# UNITED STATES PATENT AND TRADEMARK OFFICE

APPLICATION NO.	FILING DATE	FIRST NAMED INVENTOR	ATTORNEY DOCKET NO.	CONFIRMATION NO.
09/884,522	06/18/2001	Aluizio M. Cruz	265/158	3110

# Office Action Summary

FIG. 6

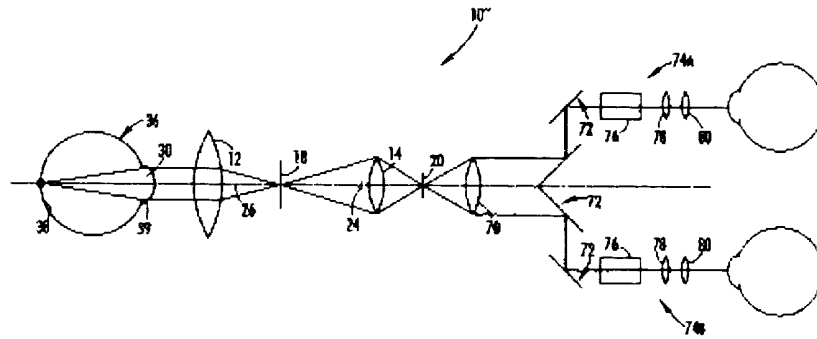
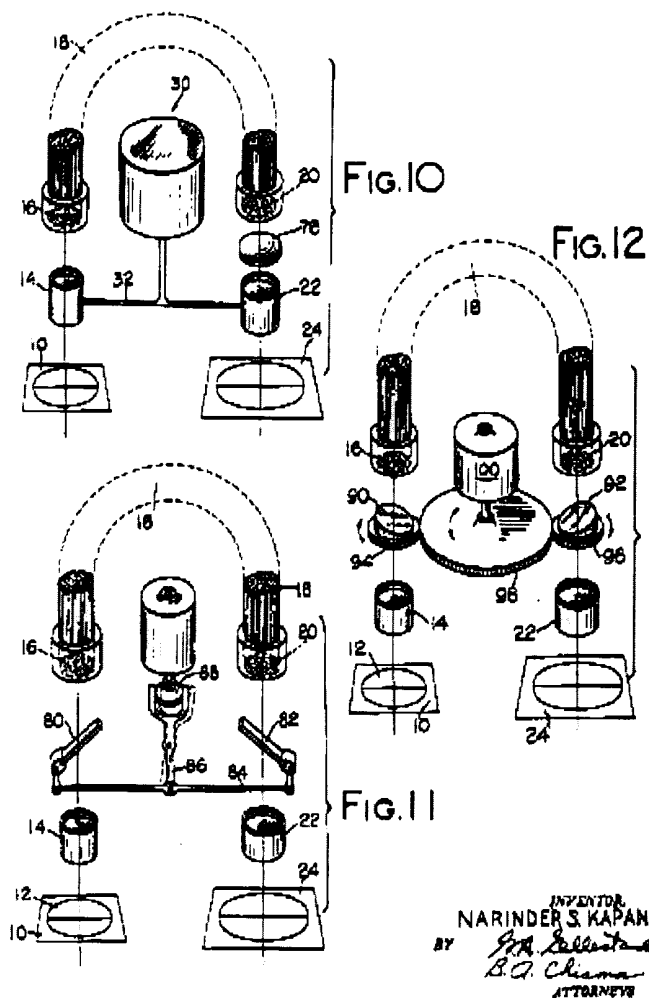
Claims 1-3,7 and 22 are rejected under 35 U.S.C. 102(b) as being anticipated by Goldfain et al (USPNO. 6,065,837).

Figure 6 of the reference clearly teaches the instant claimed invention.
